DART AEROSPACE LTD	Work Order: 159217
Description: Crosstube Assembly, Mid Aft	Part Number: D206-667-247
Inspection Dwg: D206-667-247 Rev: A	Page 1 of 2

TITLE SCALE
CROSSTUBE ASS'Y (206L MID AFT) NTS

DRAWING NO. D206-667-247	TITLE CROSSTUBE ASS'Y (206L MID AFT)	REV. A	DART AEROSPACE LTD ENGINEERING ORDER		D.E.O. NO. D206-667-247-A-1	SHEET NO. SHEET 1 OF 1	SCALE NTS
DRAWN <i>q</i>	CHECKED <i>ASS</i>	MFG. APPR. <i>KD</i>	APPROVED <i>AMP</i>		DE APPR. <i>#</i>		
DATE 11.07.15	DATE 11.07.20	DATE 11.07.21	DATE 11/07/21		DATE 11.07.21

REPLACE MAGNOBOND WITH PROSEAL.

DRAWING NO. REV. A
D206-667-247 SHEET 1 OF 4

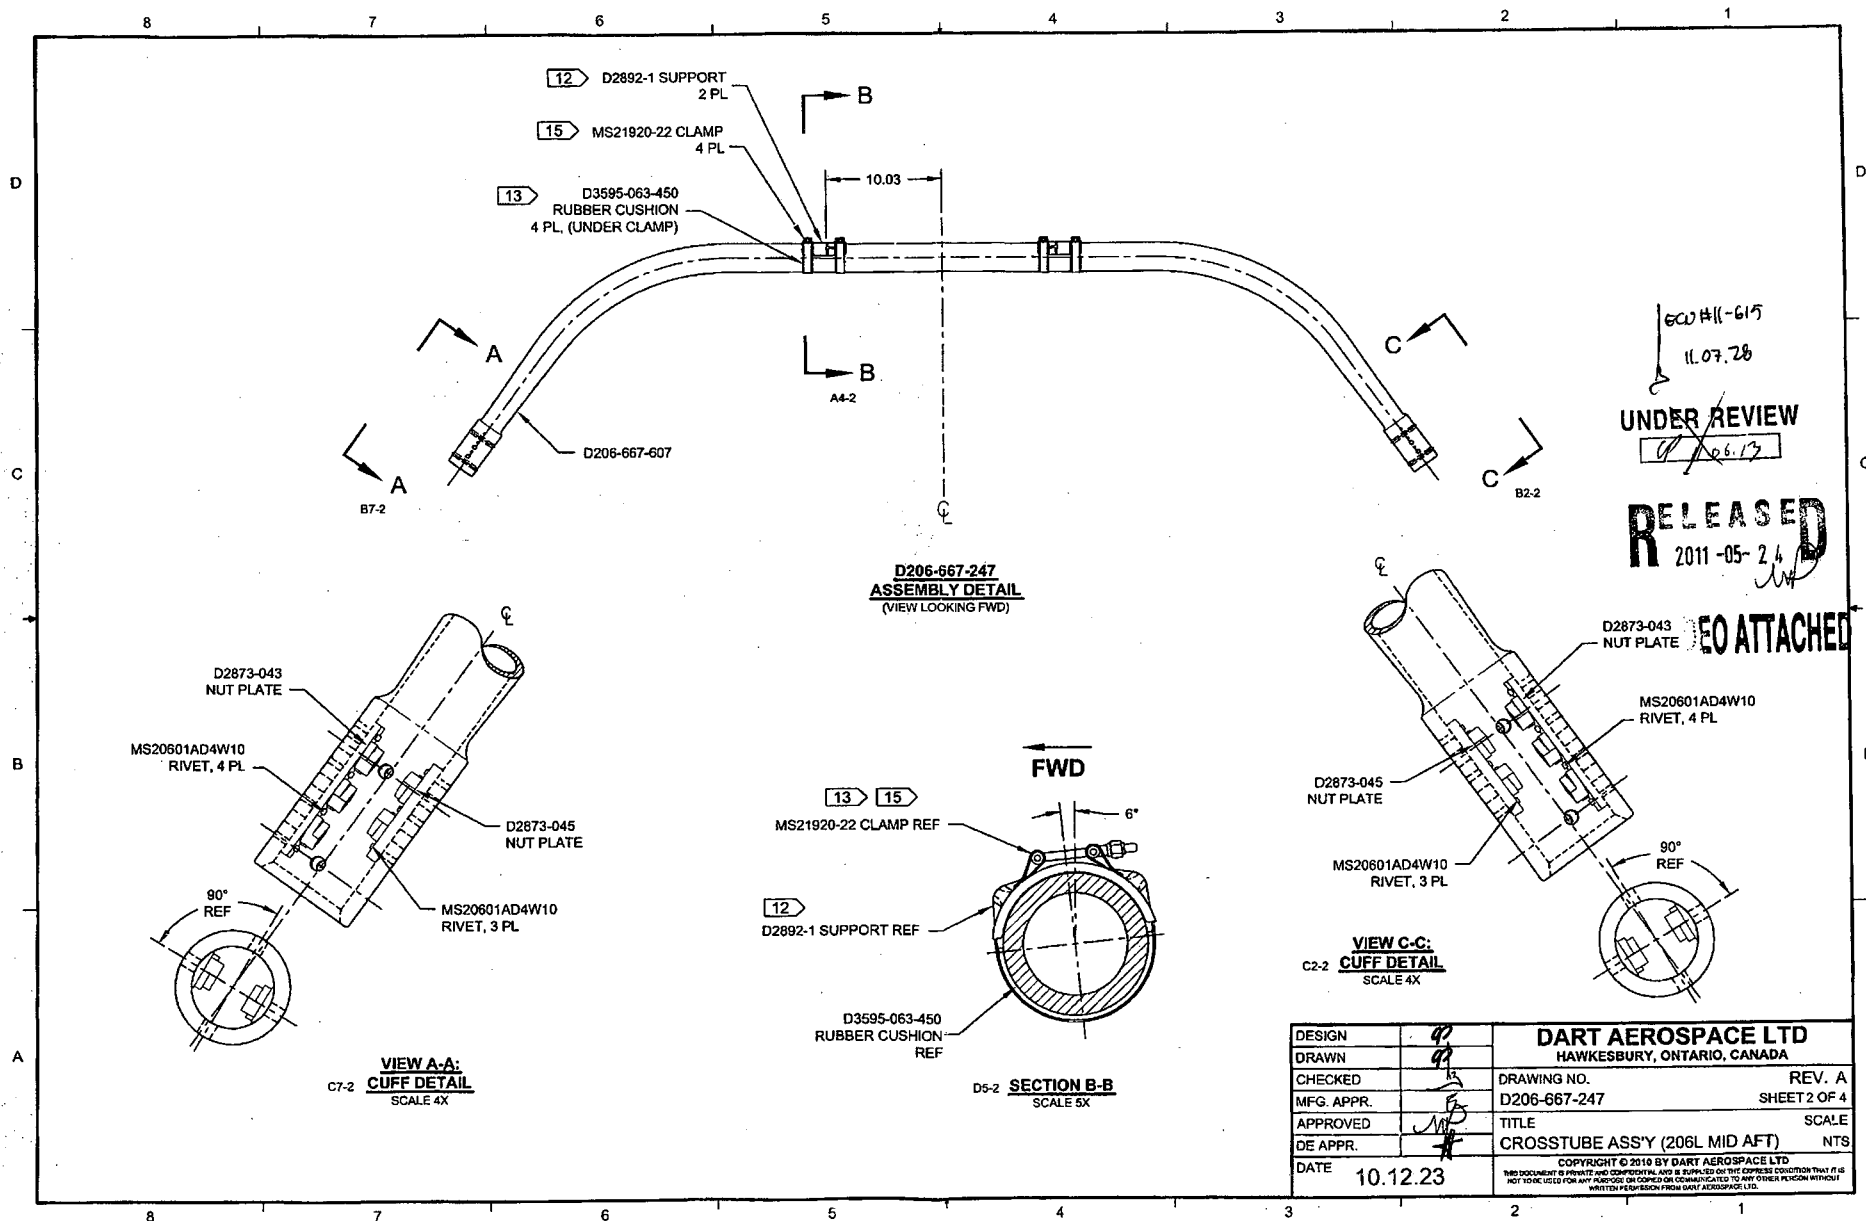
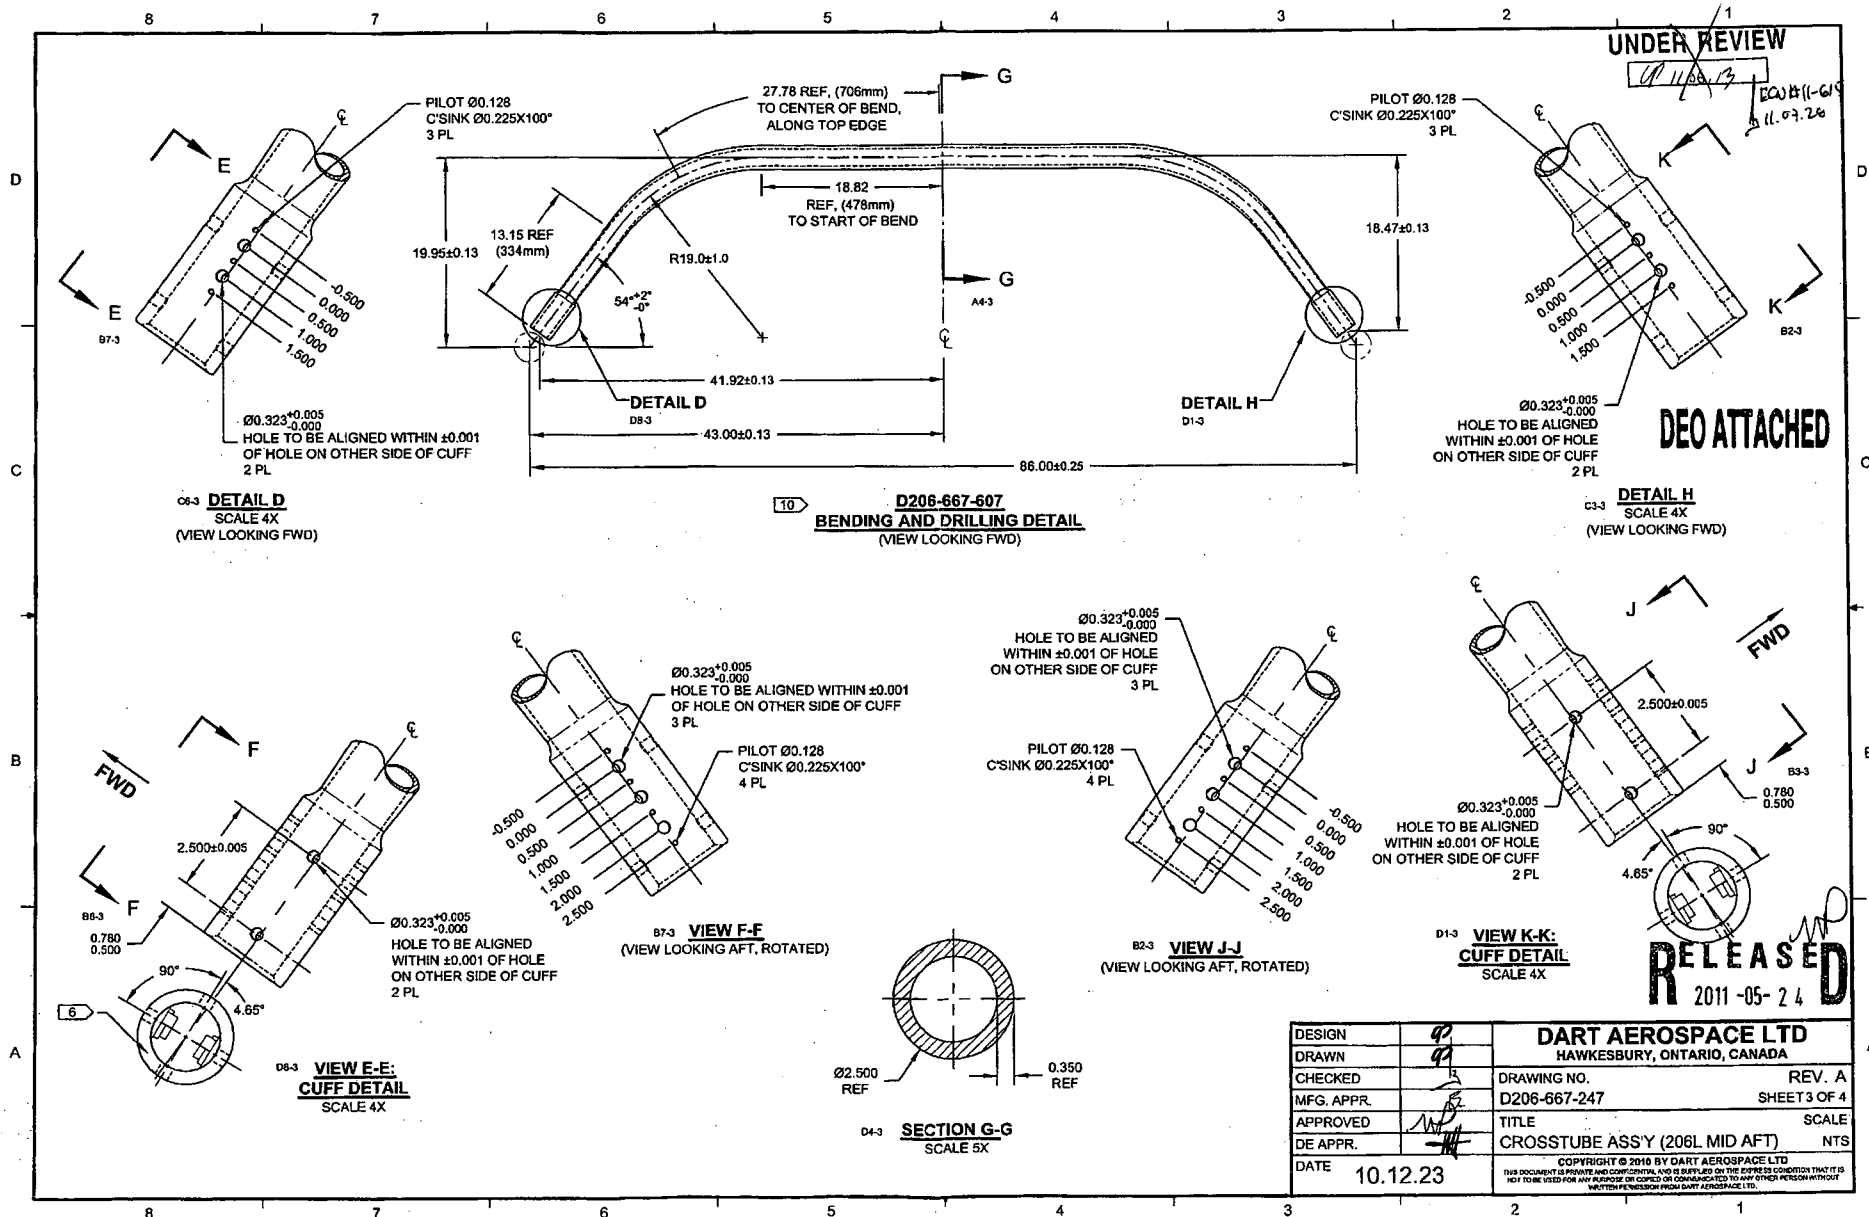
IS:

Item	Qty -247	Part Number	Description
9	A/R	PROSEAL 890 B-2	SEALANT, AMS-S-8802 CLASS B-2

WAS:

9	A/R	MAGNOBOND 6398	ROCKWELL SPECIFICATION RBO-120-023 ADHESIVE (TEXTRON/BELL SPEC. 299-947-100, TYPE II, CLASS 2 ADHESIVE)
---	-----	----------------	---

NOTE 12 & 15, SHEET 1 IS AMENDED AS FOLLOWS:

- 12) INSTALL D2892-1 SUPPORT USING 0.03" TO 0.06" THICK LAYER OF MAGNOBOND 6398 PER QSI 015. LET CURE FOR 12 HOURS AFTER INSTALLATION AND PRIOR TO PACKAGING.
- 15) TORQUE CLAMPS 80 TO 100 IN-LB. ENSURE AT LEAST 1.5 THREADS SHOWING IN SAFETY AND THAT NUT HAS NOT BOTTOMED-OUT AFTER TORQUING.

- 12) TO INSTALL D2892-1 SUPPORT: ABRASE MATING SURFACE OF SUPPORT AND CROSSTUBE WITH 180-GRIT SANDPAPER AND REMOVE RESIDUE WITH MEK (OR EQUIVALENT). APPLY A 0.04" TO 0.07" THICK LAYER OF PROSEAL 890 CLASS B-2 (OR AMS-S-8802 CLASS B-2) SEALANT TO MATING SURFACE OF SUPPORT.
- 15) TORQUE CLAMPS 80 TO 100 IN-LB. ENSURE AT LEAST 1.5 THREADS SHOWING IN SAFETY AND THAT NUT HAS NOT BOTTOMED-OUT AFTER TORQUING. **PRIOR TO PACKAGING, RE-CHECK TORQUE ON CLAMPS AFTER PROSEAL 890 SEALANT HAS CURED FOR 72 HOURS.**
